ORIGINATION FORM

Proposed Revisions to a Standard Plans Index
(Please provide all information — Incomplete forms will be returned)

Index Number: 515-052
Sheet Number (s): 5
Index Title: Pedestrian/Bicycle Railing (Steel)

TYPE 2 - CHAIN-LINK (Continuous Infill Panel)

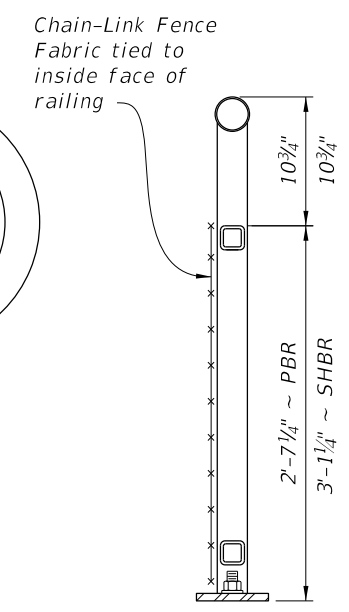
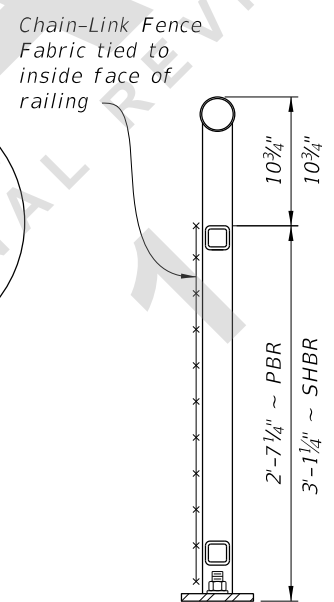
Sheet 5- Added knuckled selvage as an option to the chain-link railing option

The selvage requirements detailed on Index 515-052 were based on a conservative approach to secure the bottom edge. Using knuckle selvage top and bottom would be acceptable.

Redraw as knuckled

Knuckled Selvage (Typ.)

2" mesh with knuckled top and bottom selvage
